UNITED STATES PATENT AND TRADEMARK OFFICE

APPLICATION NO.	FILING DATE	FIRST NAMED INVENTOR	ATTORNEY DOCKET NO.	CONFIRMATION NO.
10/802,344	03/17/2004	William L. Walburn	10938/004	3642
27879	7590	07/11/2006	EXAMINER	
GABLER, PHILIP FRANCIS				
ART UNIT		PAPER NUMBER		
3637

Office Action Summary	Application No.	Applicant(s)
	10/802,344	WALBURN, WILLIAM L.
	Examiner	Art Unit
	Philip Gabler	3637

DETAILED ACTION

Fetch '305 Figure 1

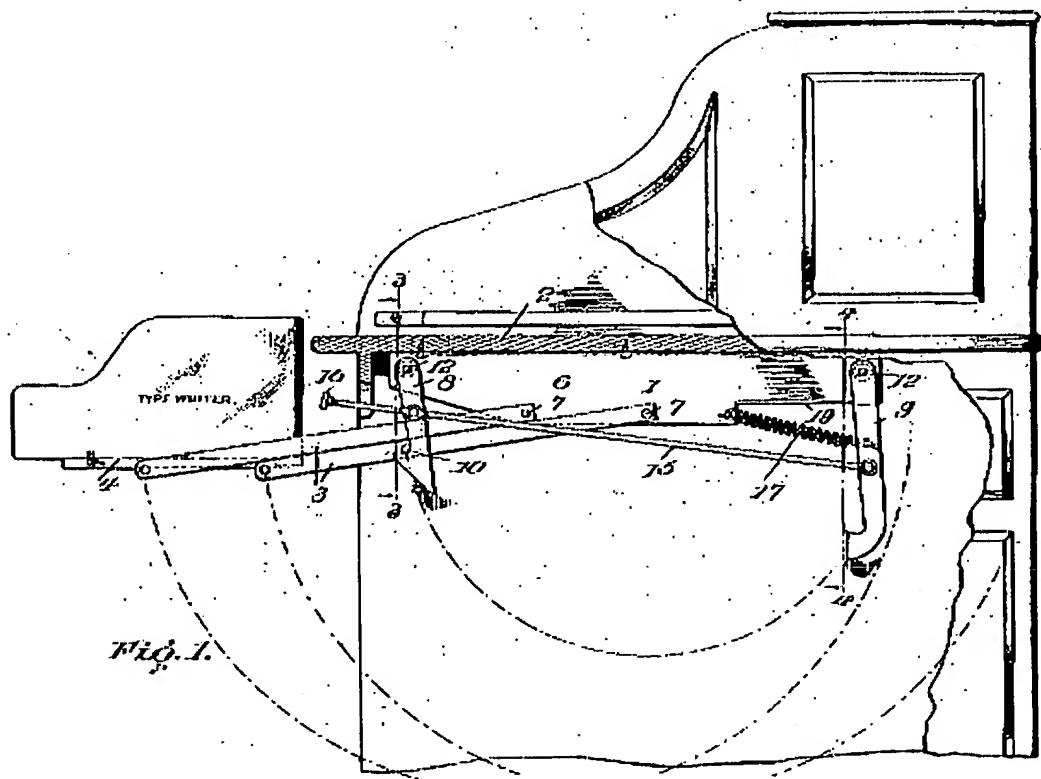
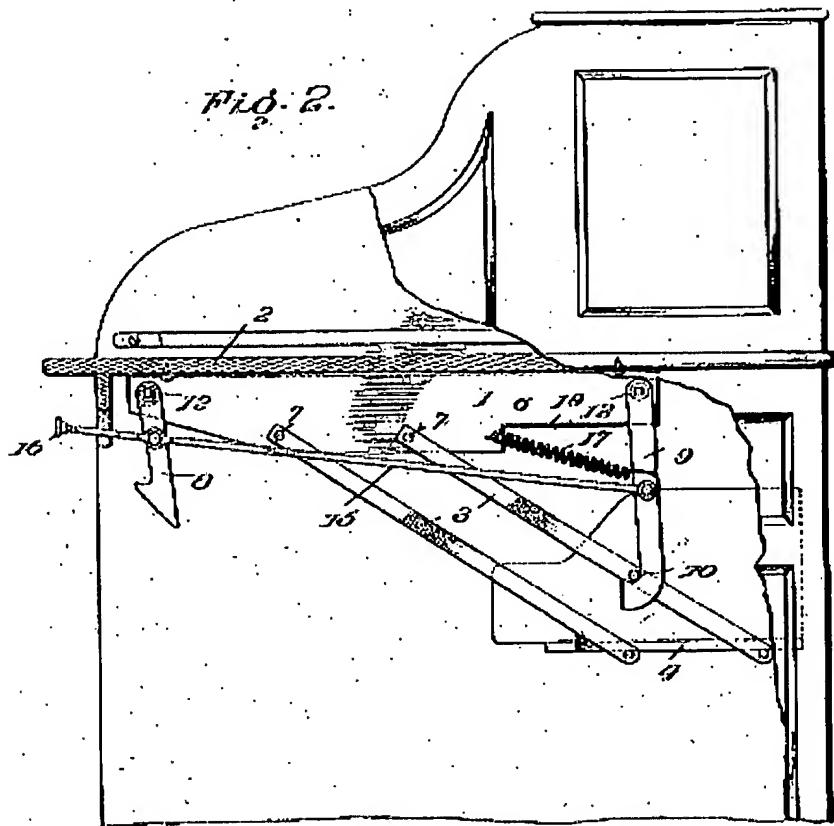
2. Claims 1 and 8-10 are rejected under 35 U.S.C. 102(b) as being anticipated by Fetch (US Patent Number 883305). Fetch (Figures 1 and 2) discloses a shelf lift system comprising: a support bracket (6), a first and second pivot (both labeled 7) coupled to the bracket, first and second bars (both labeled 3) respectively coupled to the first and second pivots for movement relative to the support bracket, a shelf support (4) coupled to the first and second bars for movement with the bars relative to the bracket between an upper and a lower position (see Figures 1 and 2), one of the first and second bars including a stop contact portion (10 and surrounding section of bar), and a cushion (9, which acts as a stop or rest for the stop contact portion) fixed to the support bracket at a position to intercept the bar stop contact portion when the shelf support moves to the lower position.

3. Regarding claim 8, Fetch further discloses a latch (8) coupled to the shelf support (indirectly, via the linkage) and a latch pin (10) coupled to one of the first and second bars at a position that permits engagement of the latch pin and latch when the shelf support is in the upper position (see Figure 1).

4. Regarding claim 9, Fetch further discloses a latch release lever (15) coupled to the latch to facilitate the release of the latch from the latch pin, and a latch biasing member (17) coupled to the latch (through members 9 and 15) to bias the latch toward engagement with the latch pin.

5. Regarding claim 10, Fetch further discloses lever mounting pins (attachment points of lever 15 to members 8 and 9) for movably mounting the latch release lever to the shelf support (indirectly, via the linkage), the lever including a handle (16) facilitating the movement of the latch release lever and latch relative to the shelf support.

Schreyer '761 Figures 2 and 3

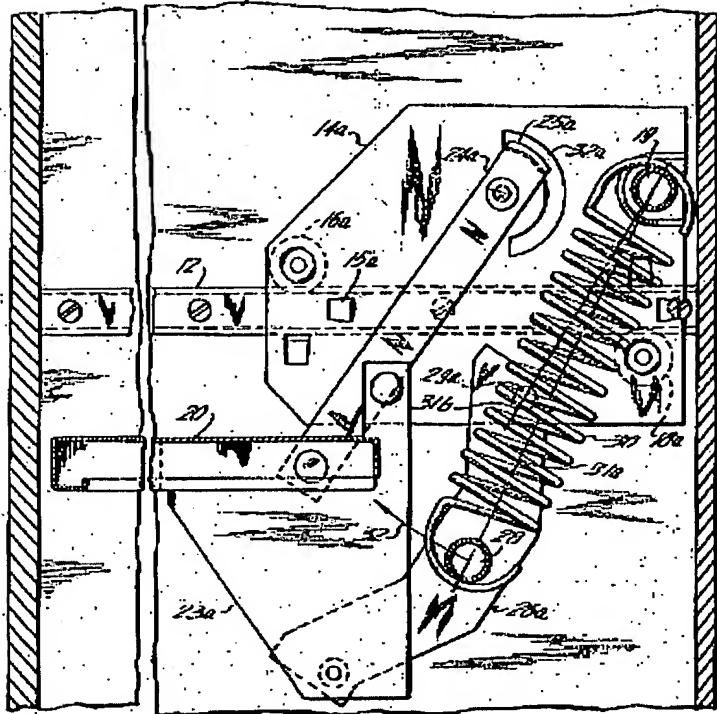
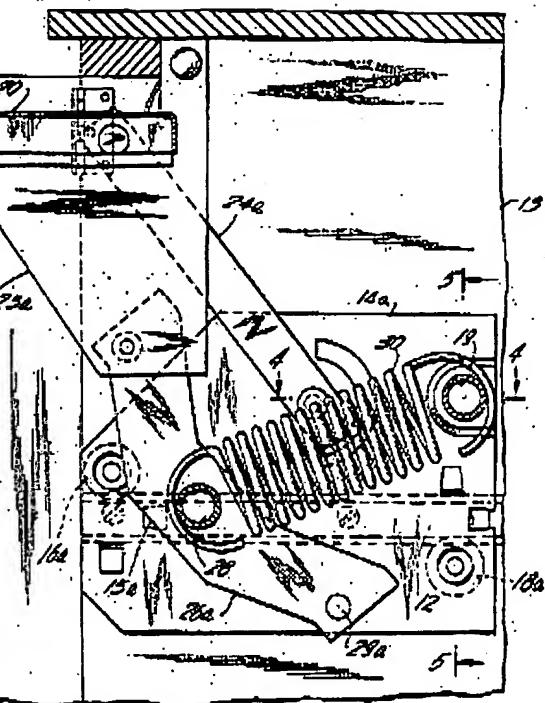
7. Claims 1-6 and 18 are rejected under 35 U.S.C. 103(a) as being unpatentable over Schreyer in view of in view of Foster (US Patent Number 4657214). Schreyer (Figures 2 and 3) discloses a shelf lift system comprising: a support bracket (14a), a first

(upper pivot of arm 24a) and second (29a) pivot coupled to the bracket, first (24a) and second (26a) bars respectively coupled to the first and second pivots for movement relative to the support bracket, a shelf support (23a) coupled to the first and second bars for movement with the bars relative to the bracket between an upper and a lower position (see Figures 2 and 3), one of the first and second bars including a stop contact portion (25a), and a slot (32a) formed on the support bracket at a position to intercept the bar stop contact portion when the shelf support moves to the lower position but does not disclose a cushion *fixed* to the support bracket. Foster (Figure 6) discloses a shelf system including a rubber (see for example column 5 lines 52-53) bumper (88) fixed to a stop or cushion (86). Accordingly, it would have been obvious to add a rubber bumper/cushion to the slot of Schreyer's system to provide a soft stop for the mechanism to reduce noise and prevent jarring of the contents of the shelf.

8. Regarding claim 2, Schreyer, as modified by Foster as described above, discloses the cushion is fixed between the first and second pivots.

9. Regarding claim 3, Schreyer further discloses the stop contact portion (25a) comprises an end portion of one of the bars (24a) extending from one of the first and second pivots away from the shelf support (23a).

10. Regarding claim 4, Schreyer, as modified by Foster as described above, discloses a biasing member (30) having a first end coupled to the support bracket (via rod 19) and a second end coupled to one of the first and second bars (via rod 28) applying a force there between, said cushion being generally situated along a line

between the first and second ends of the biasing member when the shelf support is in the upper position (see Figure 3).

11. Regarding claim 5, Schreyer, as modified by Foster as described above, discloses the first and second ends of the biasing member are situated in an over-center relationship with respect to at least one of the first and second pivots when the shelf support is moved to the lower position, so that the bar stop contact portion is biased into contact with the cushion (see Schreyer Figure 2 and column 3 lines 5-26).

12. Regarding claim 6, Schreyer further discloses a tension adjustment member (28) coupled to the biasing member for adjusting the force applied by the biasing member. [Translation of member 28 during rotation of member 26a will alter the length of biasing member 30 and accordingly adjust the force applied by the member.]

Foster '214 Figure 6

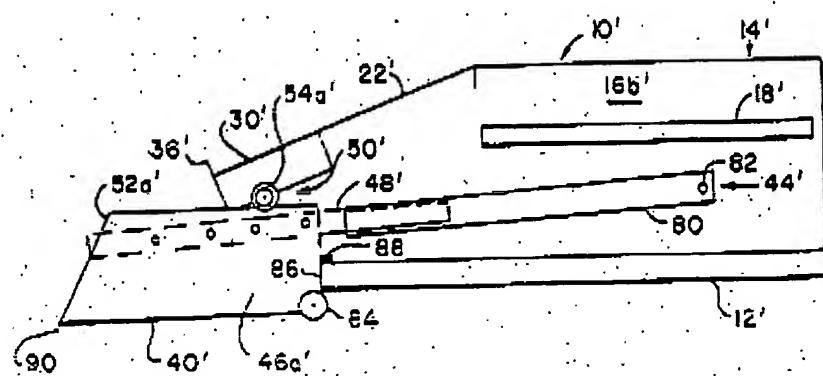
Schreyer does not disclose a cushion *fixed* to the support bracket or a tension adjustment plate. Foster (Figure 6) discloses a shelf system including a rubber (see for example column 5 lines 52-53) bumper (88) fixed to a stop or cushion (86). Accordingly, it would have been obvious to add a rubber bumper/cushion to the slot of Schreyer's system to provide a soft stop for the mechanism to reduce noise and prevent jarring of the contents of the shelf. Schneller (Figures 8 and 10) discloses a shelf lift system (Figure 8) including a tension adjustment plate (washer or flange labeled A in Exhibit 1, which is functionally equivalent to a tension adjustment plate) coupled to a biasing member (26) and pivotally coupled to a component (24) of a shelf lift system for movement relative to a support bracket (also 24) to provide adjustable biasing force, and a fastener (27) for securing the tension adjustment plate. Accordingly, it would have been obvious to one of ordinary skill in the art at the time the invention was made to modify Schreyer's lift system to include a tension adjustment plate as taught by Schneller because this arrangement would allow fine tuning of the lifting and lowering assistance provided by the system.

Exhibit 1: Schneller '623 Figures 8 and 10

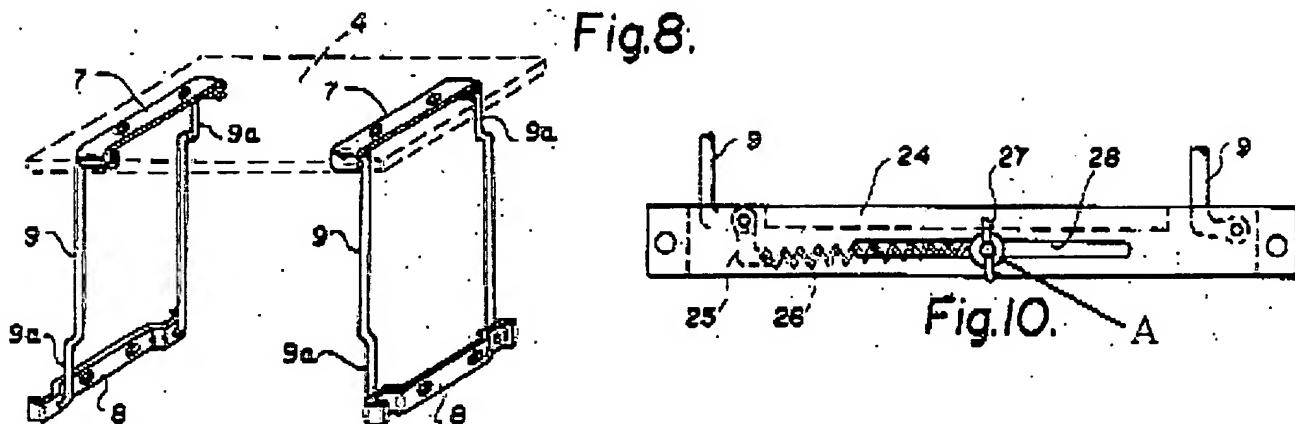
14. Claims 7, 11, 16, and 19 are rejected under 35 U.S.C. 103(a) as being unpatentable over Schreyer in view of Foster and further in view of Schneller (US Patent Number 3857623). Schreyer, when modified by Foster as described above, discloses a shelf lift system as recited in claim 6 but does not disclose a tension adjustment plate. Schneller (Figures 8 and 10) discloses a shelf lift system (Figure 8) including a tension adjustment plate (washer or flange labeled A in Exhibit 1, which is functionally equivalent to a tension adjustment plate) coupled to a biasing member (26) to permit changes in length of the biasing member (the assembly of Figure 10 replacing component 8 of Figure 8 – see column 3 lines 42-51). Accordingly, it would have been obvious to one of ordinary skill in the art at the time the invention was made to modify Schreyer's lift system, previously modified by Foster, to include a tension adjustment plate as taught by Schneller because this arrangement would allow fine tuning of the lifting and lowering assistance provided by the system.

Koch does not disclose a tension adjustment plate. Schneller (Figures 8 and 10) discloses a shelf lift system (Figure 8) including a tension adjustment plate (washer or flange labeled A in Exhibit 1, which is functionally equivalent to a tension adjustment plate) coupled to an end of a biasing member (26) and pivotally coupled to a bar (9 through element 25), and a fastener (27) for securing the tension adjustment plate at a selected position to provide a biasing force to aid in movement of a shelf (4).

Exhibit 2: Koch '075 Figures 1-3

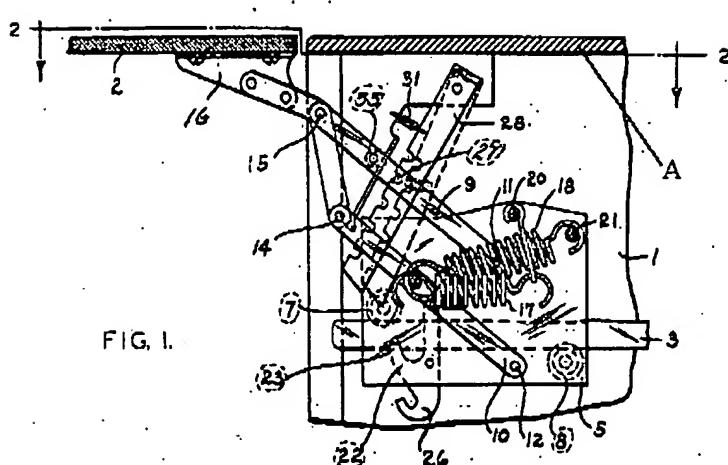
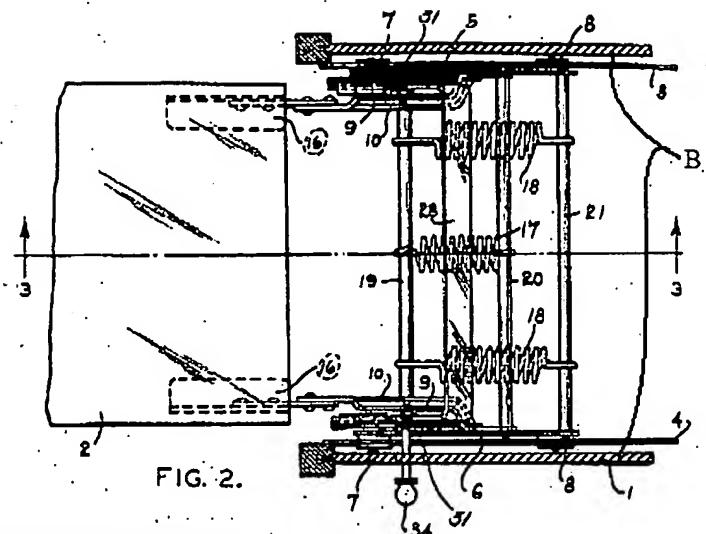
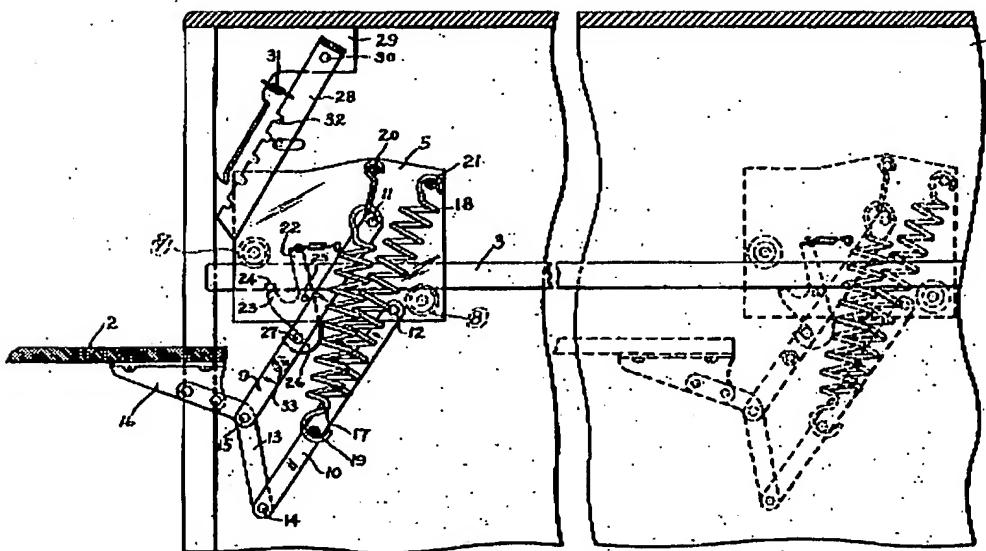
21. Claim 17 is rejected under 35 U.S.C. 103(a) as being unpatentable over Koch (US Patent Number 2541075) in view of Schneller. Koch (Figures 1-3) discloses a shelf lift system for use in a cabinet (1) having a top surface (viewed as A in Exhibit 2) and a pair of sidewalls (B) defining a space below the top surface, the shelf lift system comprising a pair of support brackets (5 and 6), each bracket having a mounting surface to be fixed to one of the sidewalls (via tracks 3 and 4), a first and second pivot (11 and 12) coupled to each bracket, a swingable linkage including first and second bars (9 and 10) respectively coupled to the first and second pivots of each bracket for movement relative to each support bracket, shelf supports (16) coupled to each of the first and second bars (via member 13) and supporting a common shelf (2) for movement of the shelf with the bars relative to the brackets between and upper position wherein a shelf (2) is situated generally coplanar with the cabinet top surface (see Figure 1) and a lower position wherein the shelf is situated fully within the cabinet below the top surface (see Figure 3), biasing members (18) having first ends coupled to one of the support brackets (via 21) and second ends, latches (28) coupled (indirectly) to the shelf supports and latch pins (27) coupled to one of the first and second bars at a position

permitting engagement of the latch pin and latch when the shelf is in the upper position (see Figure 1), a latch release lever (34) coupled to the latch to facilitate release of each latch from any engaged latch pin to allow the shelf to move to the lower position, and cushions (26, which act as a stops or rests for a stop contact portion) fixed to each support bracket at a position to intercept a stop contact portion (27 and surrounding section of bar) of one of the bars when the shelf support moves to the lower position.

Accordingly, it would have been obvious to one of ordinary skill in the art at the time the invention was made to modify Koch's lift system to include a tension adjustment plate as taught by Schneller because this arrangement would allow fine tuning of the lifting and lowering assistance provided by the system.
